PROJECT NAME: North West Cambridge Masterplan

SCHEDULE OF APPLICANT'S RESPONSES TO COMMENTS RECEIVED

COMMENTS RECEIVED FROM:	Lead Local Flood Authority (LLFA)	FORMAT:	Email	DATE RECEIVED:	28/10/2025
SUBJECT:	Flood Risk and Surface Water Drainage

SHEET NUMBER **REV**
 NWC-MP2024-ACM-SW-SK-05012 P02

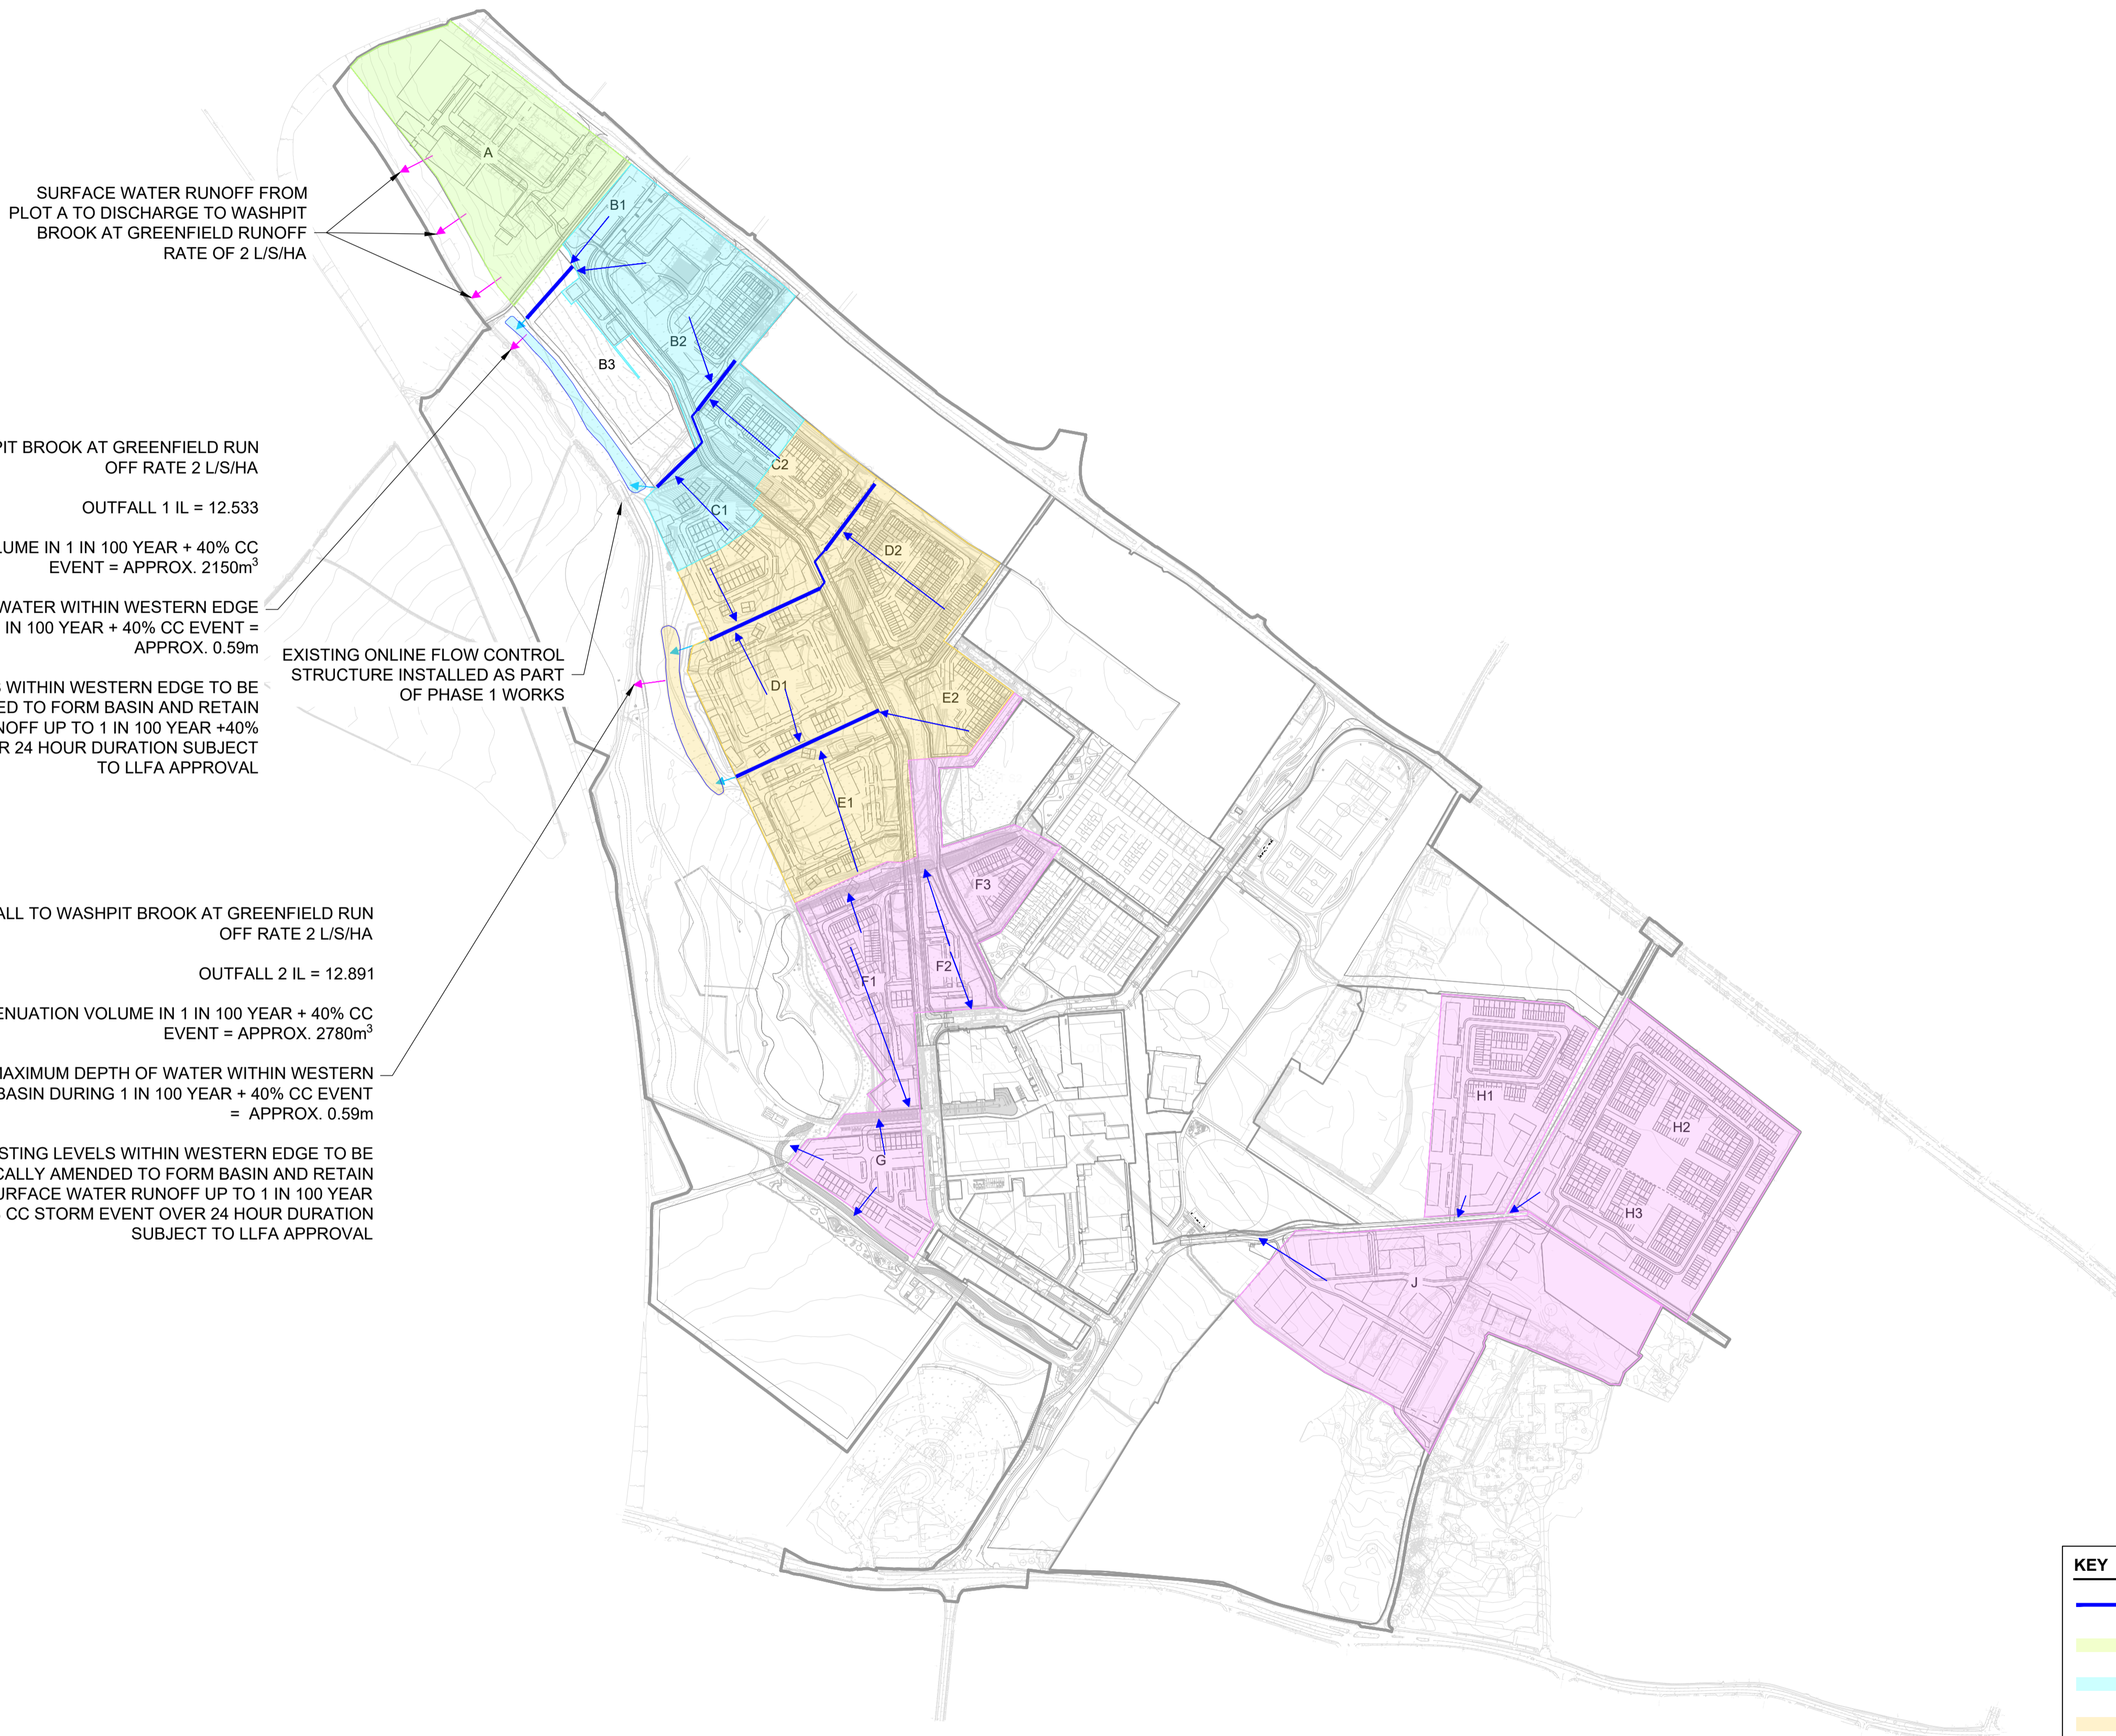
ID	ISSUE	COMMENT	RESPONSE
7.	Surface water runoff from highways and paved areas	The strategy proposes that surface water runoff from external areas including highways and other paved areas outside of the Building Development Zone boundaries will discharge unrestricted into the sitewide drainage network, this approach is not accepted. All impermeable areas should be restricted to appropriate runoff rates, achieving greenfield runoff rate where possible.	Surface water runoff from highways and external areas outside of the plot boundaries will be conveyed unrestricted to the sitewide drainage network where the flows will be restricted and attenuated within the proposed sitewide attenuation features (detention basins, swales/oversized pipes) prior to discharge to the watercourse.

SHEET NUMBER **REV**
 NWC-MP2024-ACM-PL-SK-05001 P02

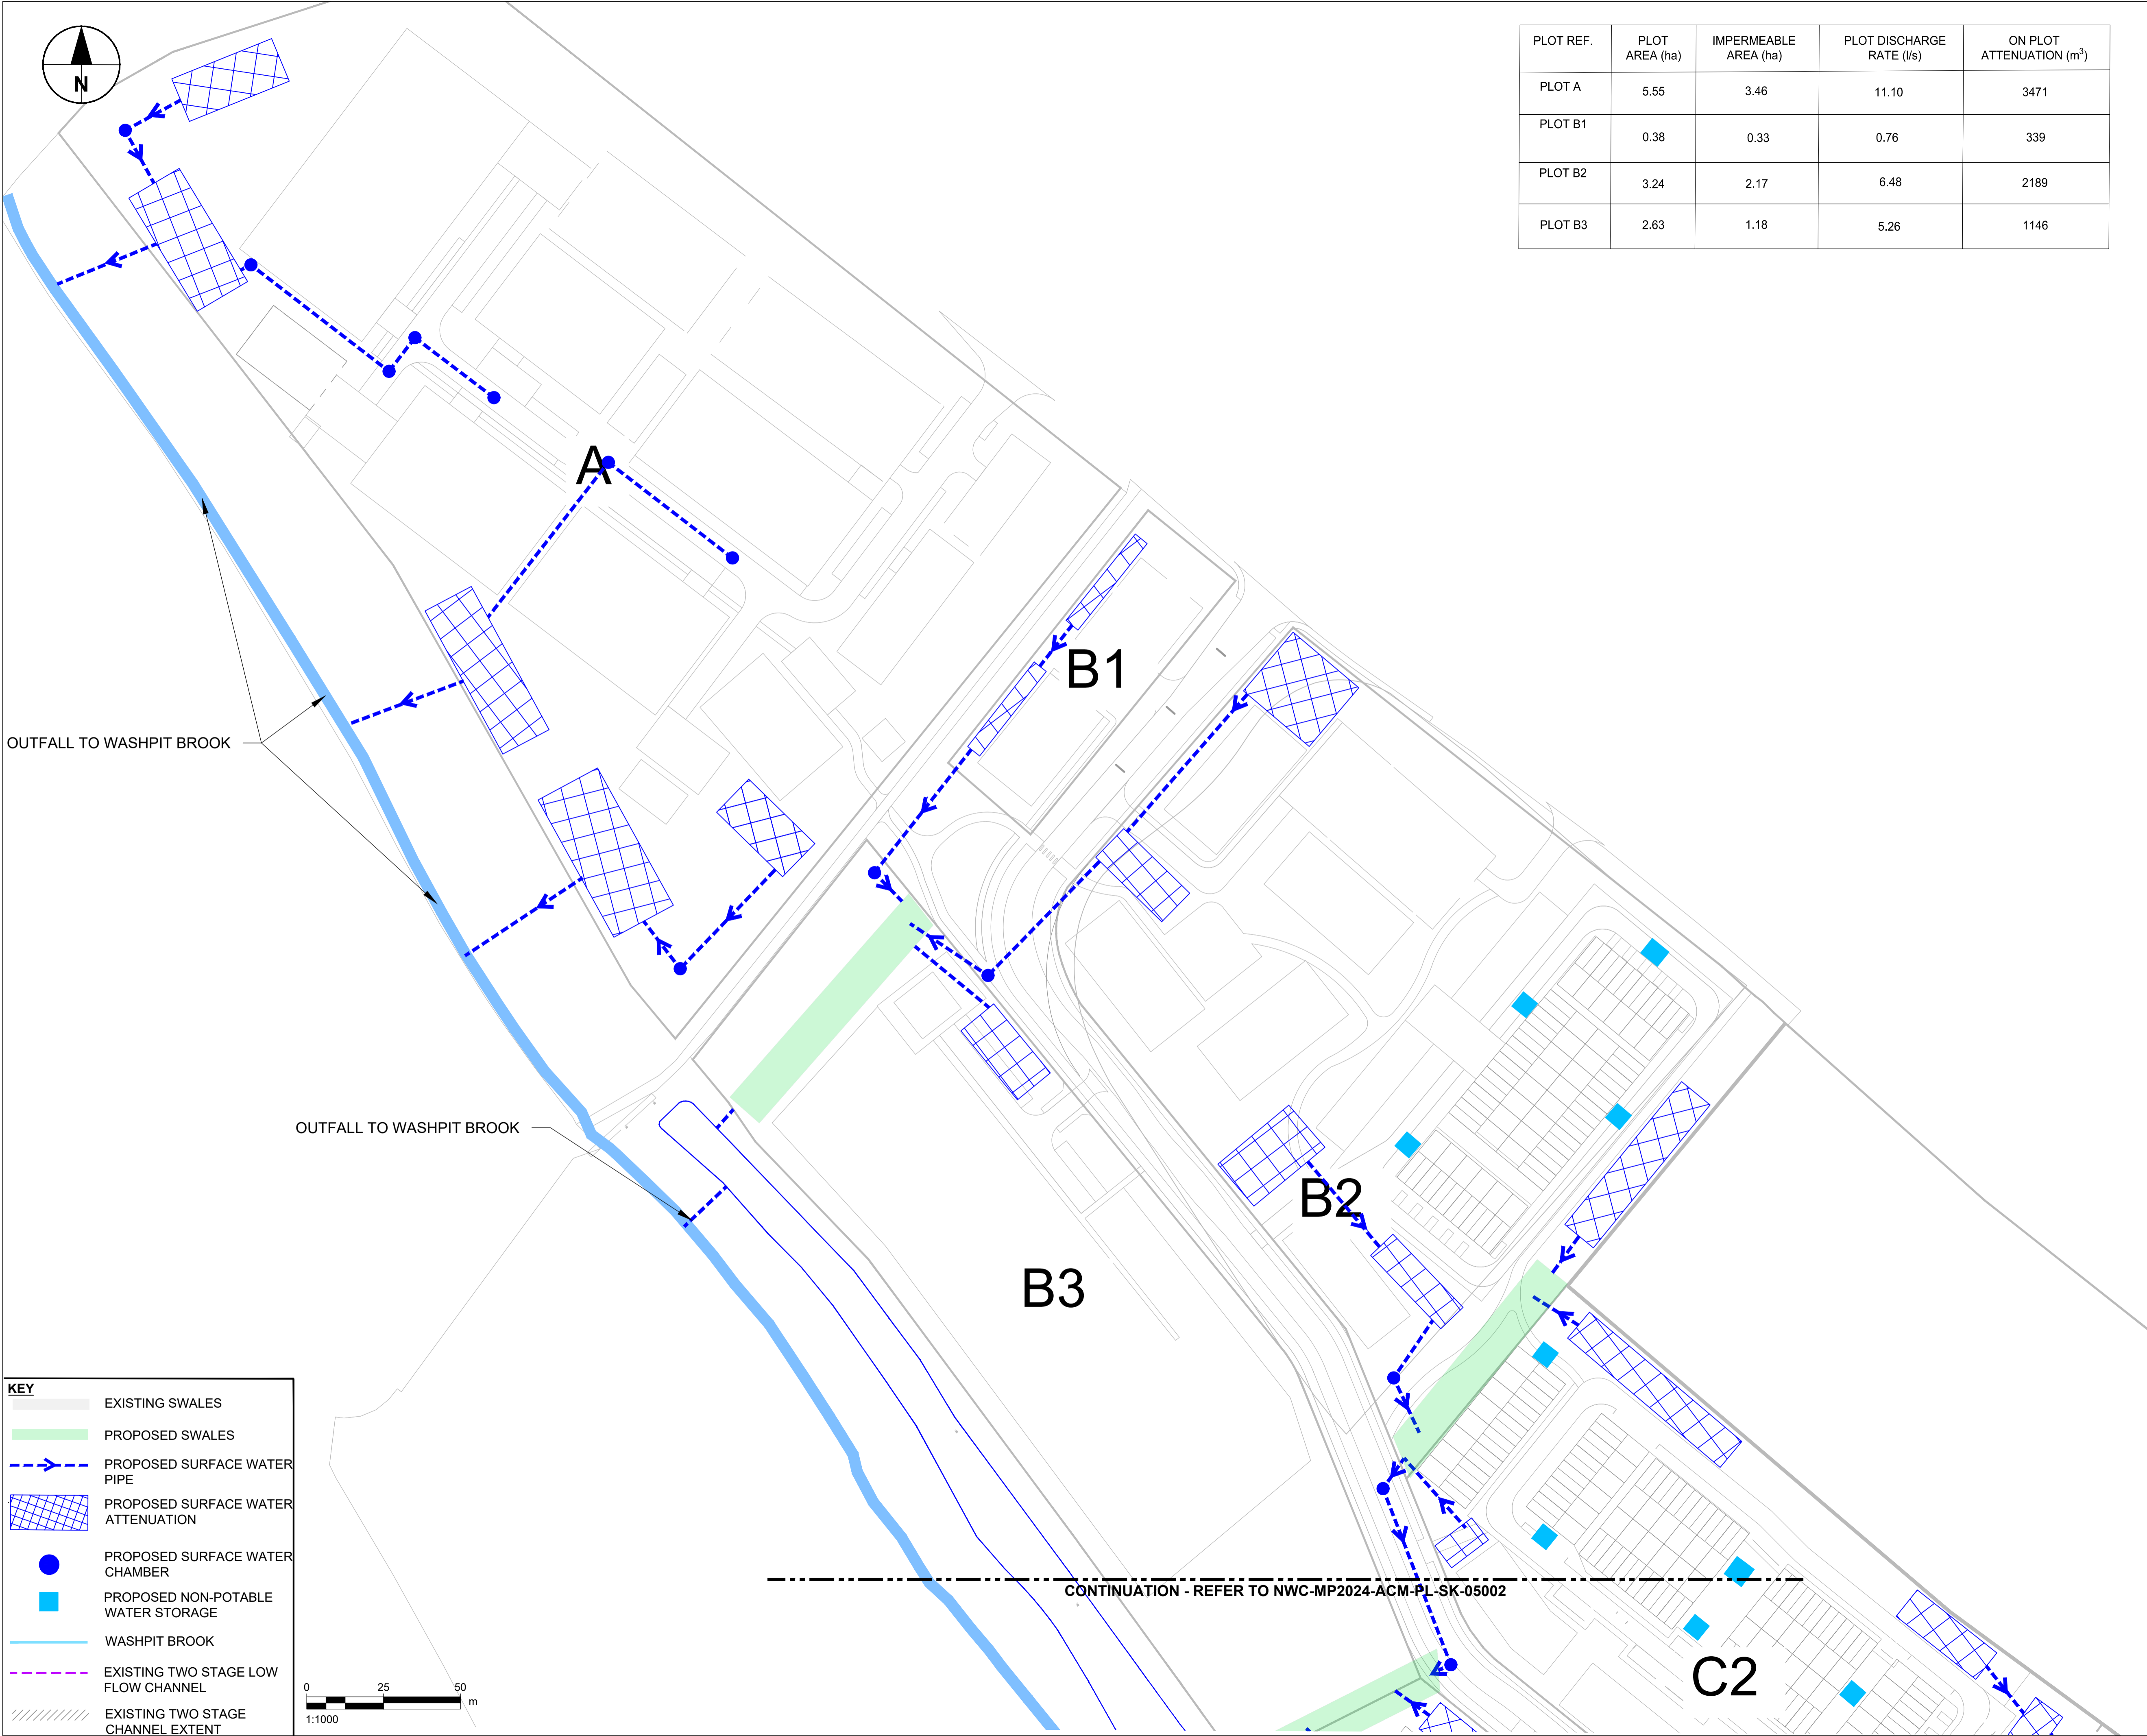
ID	ISSUE	COMMENT	RESPONSE
2.	Impermeable drained area plan	In order for us to accurately assess the proposed scheme, an impermeable drained area plan must be submitted showing an accurate area (hectares) for each plot and the required attenuation for each plot. At present this has not been provided as part of the application.	Drawings NWC-MP2024-ACM-PL-SK-05001 to 05004 submitted as part of the FRA and SWDS includes tables showing the total area and impermeable area for each plot in hectares.
